b) Universal Joint Spider

Dimensions and Tolerances of Shaft Yoke, Needle Bearing Bushings, and Universal Joint Spider

Fig. 41-4/1

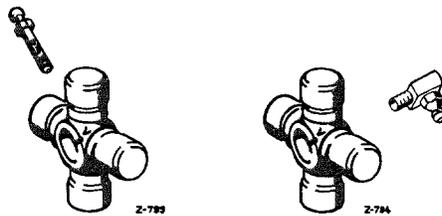
The trunnions of the spiders on the front and rear propeller shafts have been reinforced. Furthermore both the arrangement and the design of the grease fitting have been modified in order to provide better access to the grease fitting when the universal joint is greased (see table).

Arrangement and design of grease fitting		Grease fitting at an angle of 90° and screwed into end face of universal joint spider (Fig. 41-4/1)				Longer straight grease fitting, screwed in between two trunnions at an angle of 45° (Fig. 41-4/1)
